Los Angeles County Metropolitan Transportation Authority

Panel Review of the Gold Line Eastside Extension

June 29, 2009 – July 2, 2009

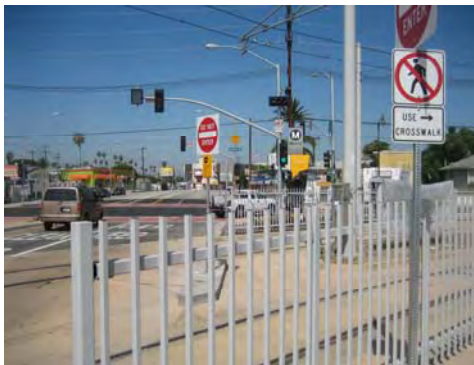
At this location, trains begin the transition from 1st Street to Indiana Avenue. The issues at 1st Street and Indiana Avenue are very similar to those of 1st Street and Alameda Avenue. However, there are multiple intersecting streets, limited sightlines, and special stopping requirements for motorists. This requires added operator attention in knowing whether it is safe to proceed. Consequently, this area will require added enforcement to ensure the intersection remains clear of vehicle encroachment. In addition to the recommendations for the 1st Street and Alameda crossing, consideration should be given to setting the stop bars farther back. The panel was encouraged to see active enforcement being conducted by members of the Los Angeles County Sheriff's Department Traffic Enforcement units.

Recommendation 17 – Stop Bar Set-back

Evaluate the current stop bar locations to determine whether they should be set back further.
